We are writing regarding the draft Report of the Environmental and Social Impact Assessment (ESIA) for the Facility "Reconstruction of SS 750 kV "Kyivska" with installation of second 750 kV autotransformer and construction of diversions of 330 kV overhead transmission lines in Kyiv region" (Facility) that is Part C and D of the 750 kV Rivne - Kyiv High Voltage Line Construction Project.

Within the scope of public consultations, NECU has analyzed the non-technical summary and the draft Report of the ESIA for the Facility and has concluded the following:

Pic 1. Fragment of the map attached to NEC Ukrenergo's reply to Uriadovjy Courier's request;

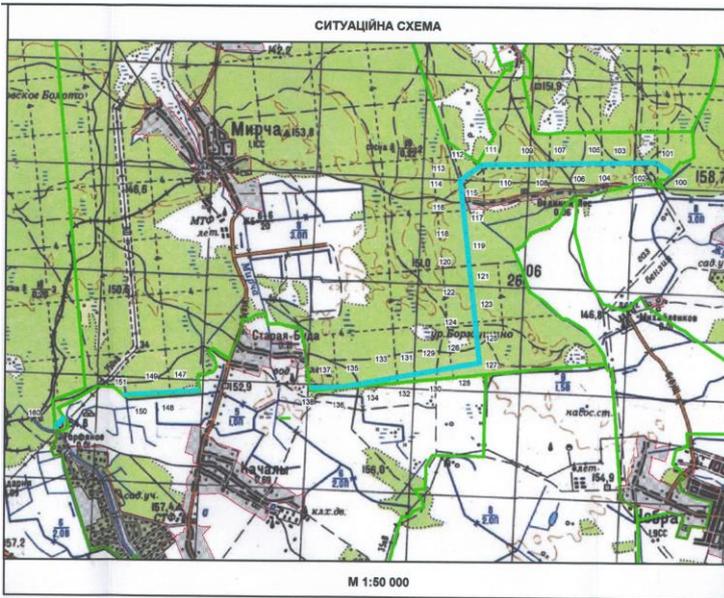
4. **The quality of cartographic materials in the draft ESIA Report, as well as the absence of general description of forests at the proposed route, does not allow to establish whether or not the planed TL rout (option no. 1) is going to affect valuable oakeries on territories between Velykyj Lis and Mircha villages (Great Forest).** From ESIA materials it is also not possible to establish if the routing was done in a way to minimize cutting down trees in forests. From the fragment of the map, attached to Ukrenergo’s reply (№ 01/02-1-1/11563 from 14 October 2014) to Uriadovyj Courier’s request, it seems that TL corridor will penetrate through forest more than suggested by the map used for public consultations (See Pic. 1 and 2). The map from the draft ESIA report suggests that TL corridor may bypass the forest and go through fields near village Mircha (See Pic. 2).

Pic 3. Fragment of the map used at public consultation meeting in Lytvynivka village on 22 August 2014.

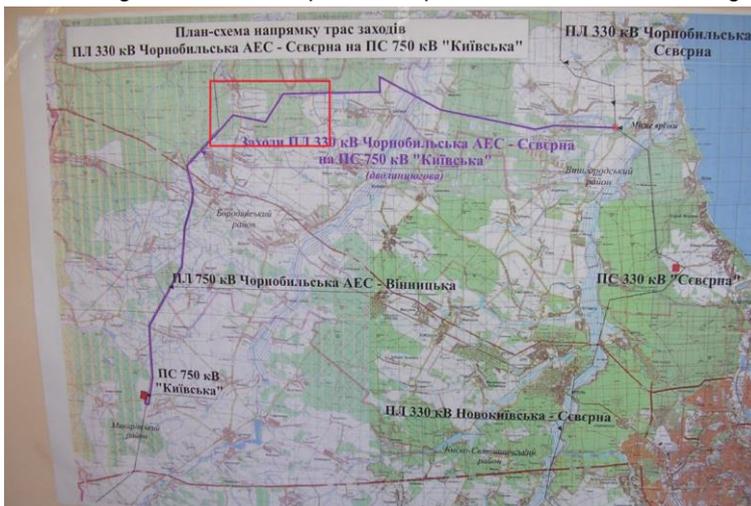
To make situation even more complicated, during public consultation meetings NEC "Ukrenergo" used the map with yet another proposed routing of this section (See Pic 3.)

Such discrepancies between information presented within the scope of public consultations and other materials available from NEC "Ukrenergo" raises doubts in the accuracy of information presented by NEC "Ukrenergo" for the public consultation.
